February 2017
FL721A-E
NHTSA #16V-656
Transport Canada #16-441
THIRD REVISED NOTICE

Subject: CNG Fuel Tank and CPDM Mounting Location

Models Affected: Specific Freightliner Cascadia vehicles manufactured September 24, 2012, through May 27, 2015, built with CNG fuel tanks

Fig. 35, Staggered Harness Splicing

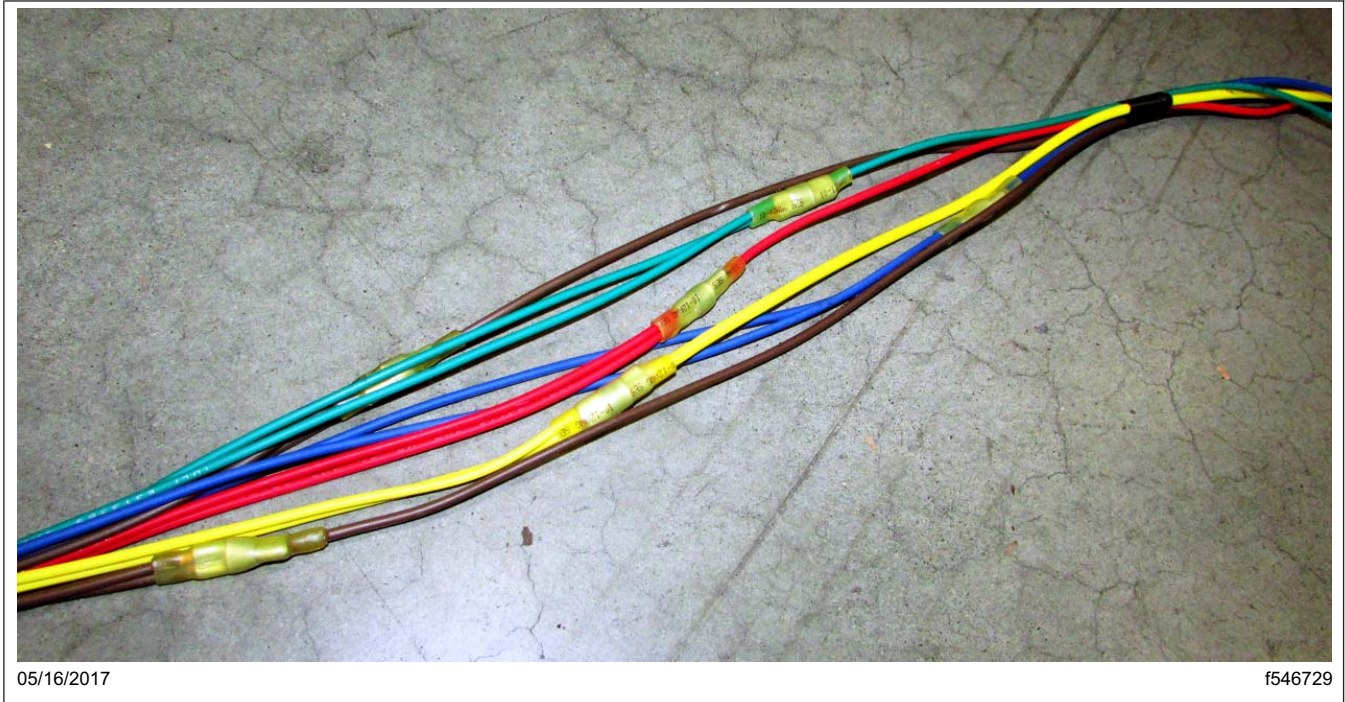
THIRD REVISION: Figure 35 has been added to FL721-C, step 37.

37. Using Phillips STA Dry Crimp Solder Seal connectors (48-02461-038) splice blunt cut individual circuit wires from harness A06-93227-000 with their corresponding circuit wire numbers on harness A06-93228-006 and A06-93229-132. Stagger the splices at varied lengths to keep bundle from becoming unmanageable. See [Fig. 35](#).
